**SECTION 00 90 01
BIDDING AND CONTRACT REQUIREMENTS
ADDENDUM NUMBER (5)**

Issued: April 30th, 2024

Re: ADDENDUM NUMBER (5) TO THE BIDDING DOCUMENTS FOR

**Peoria Park District
Golf Entertainment Facility Renovation an Addition
Architect's Project Number: 22-051**

SHEET NUMBER:
AD1.11

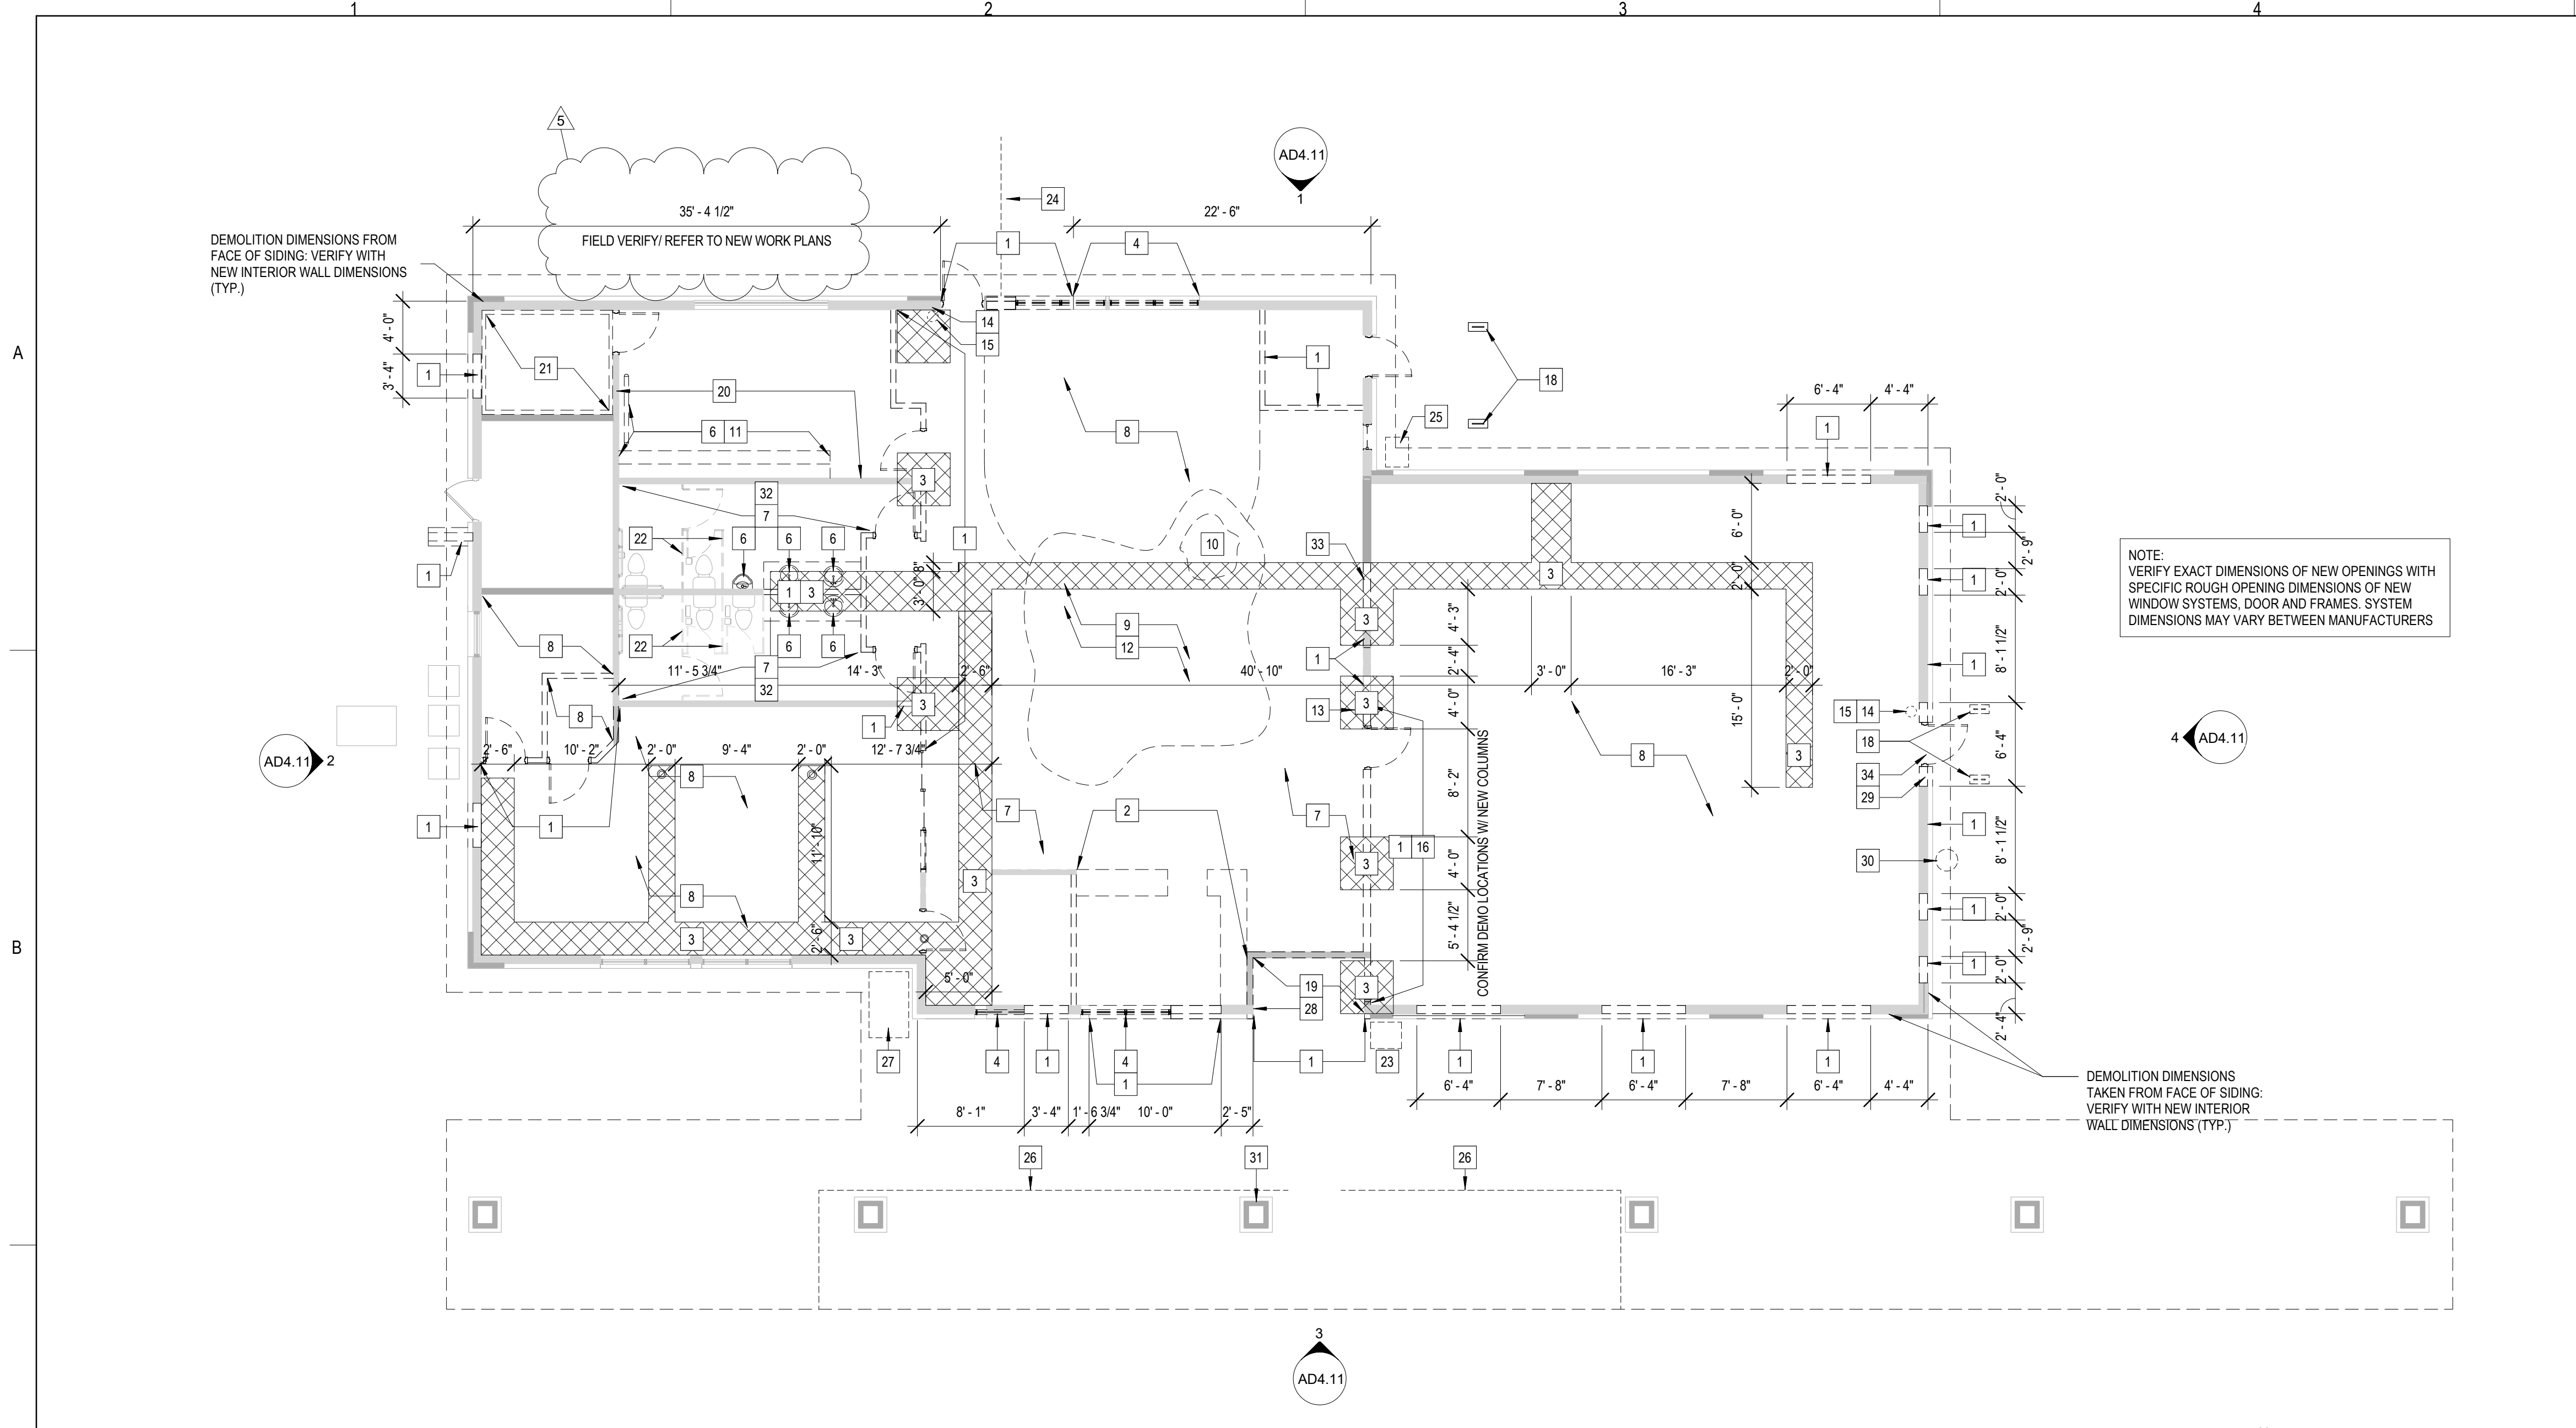
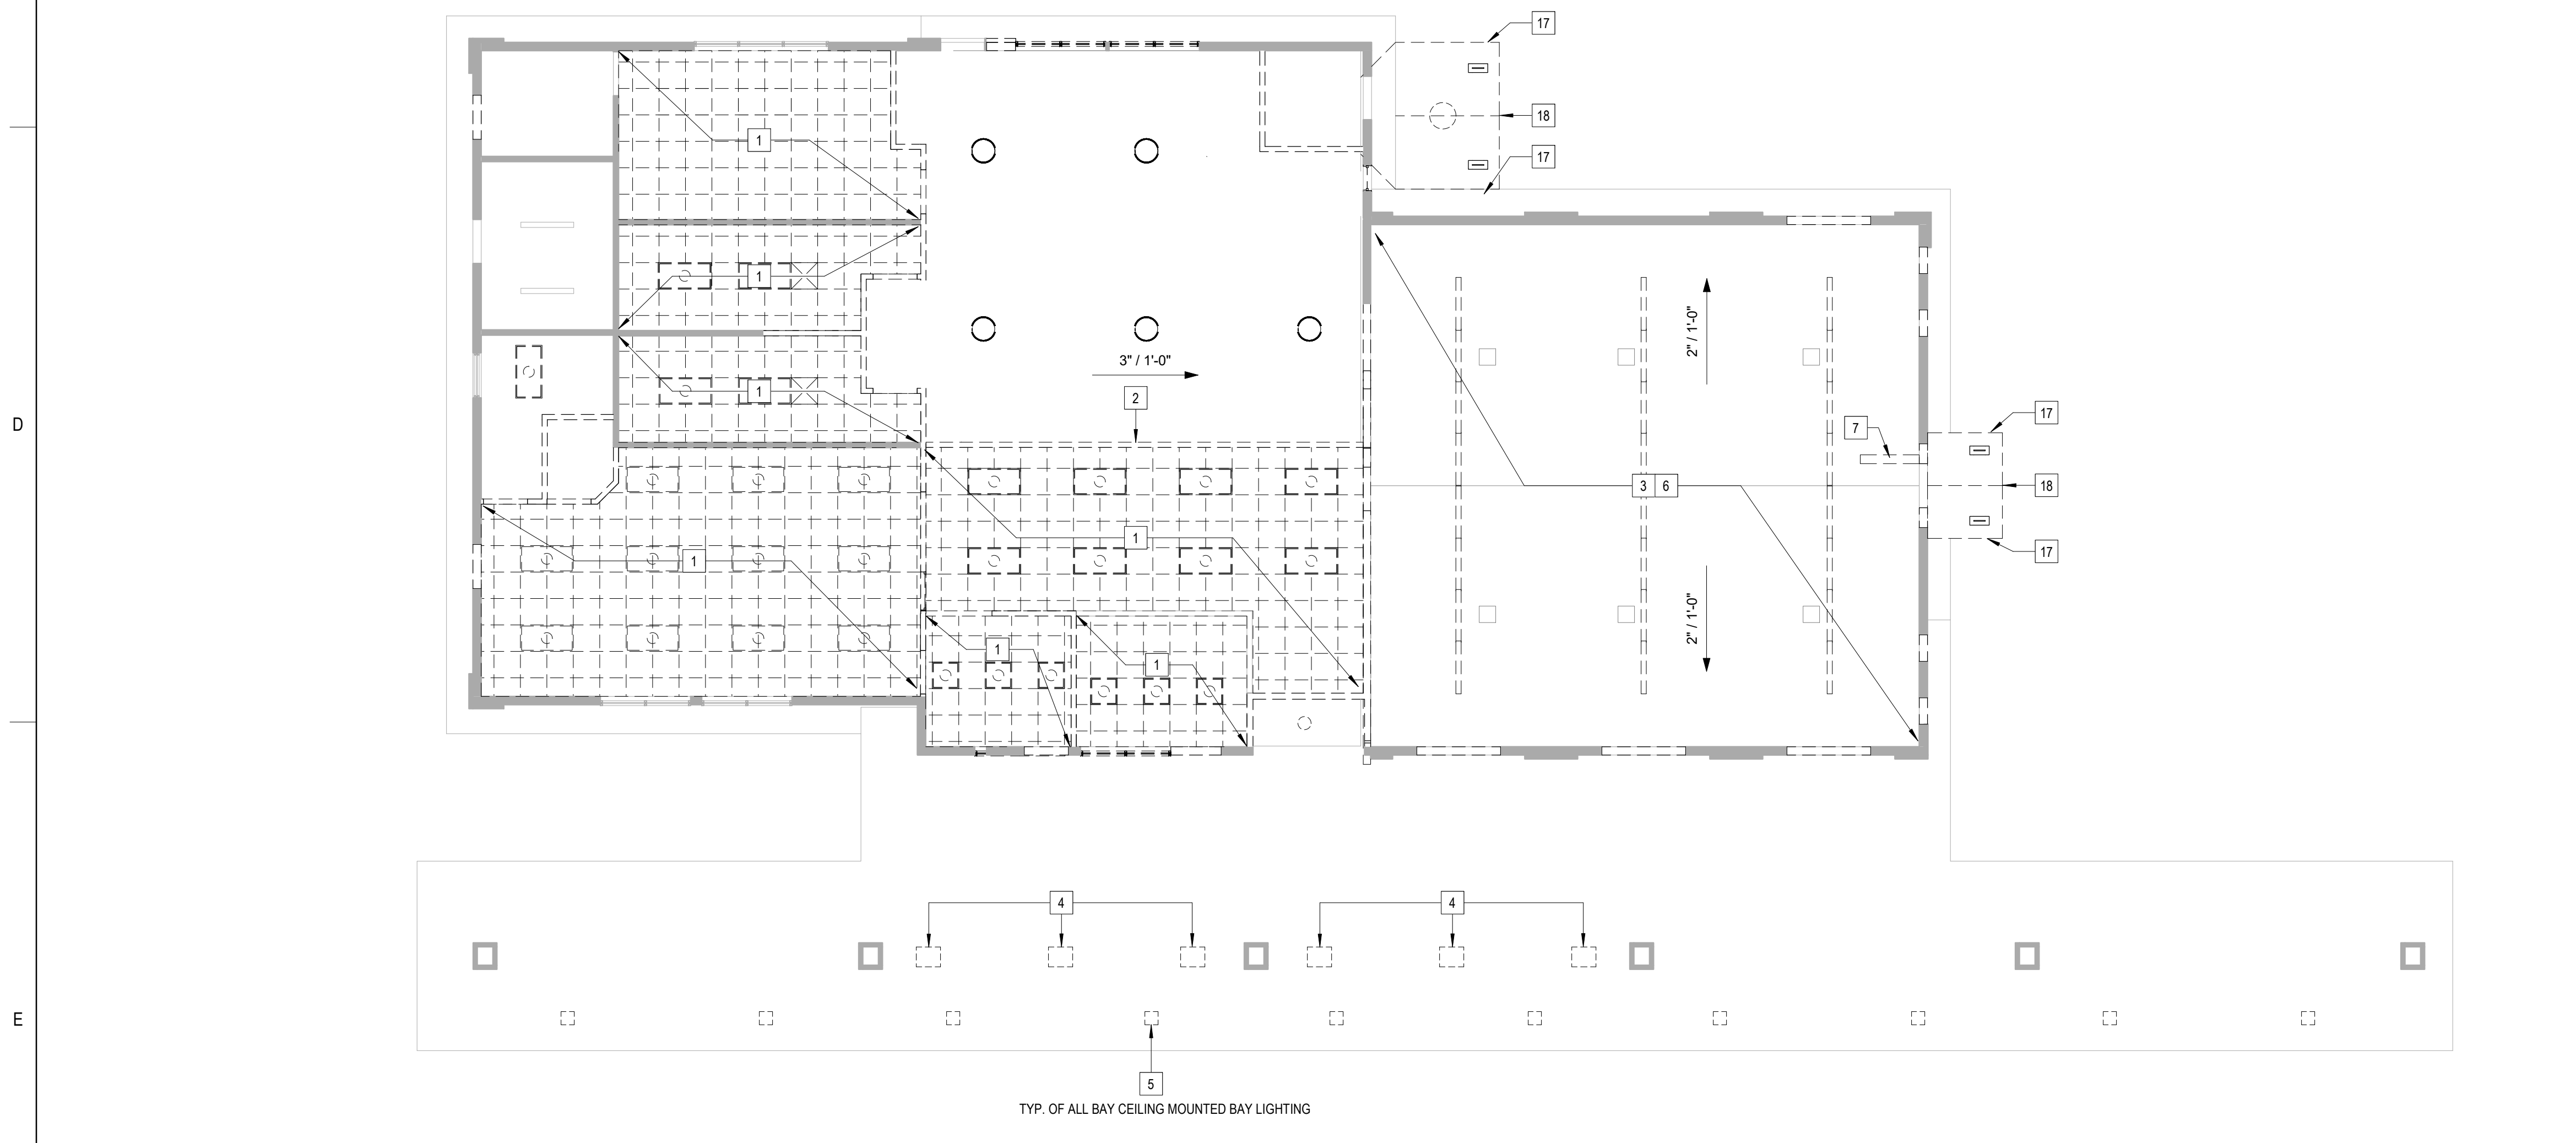
1. AD1.11 – FIRST FLOOR DEMOLITION PLAN
 - a. An extra dimension has been added for clarification of demolished openings on the north end of the building.
2. A4.02 – CLUBHOUSE ELEVATION
 - a. NOTE (and graphic) clarifying the masonry infill is to match existing adjacent.
3. A11.01 – FINISH PLANS
 - a. Finishes added in the corridor between public corridor and kitchen.
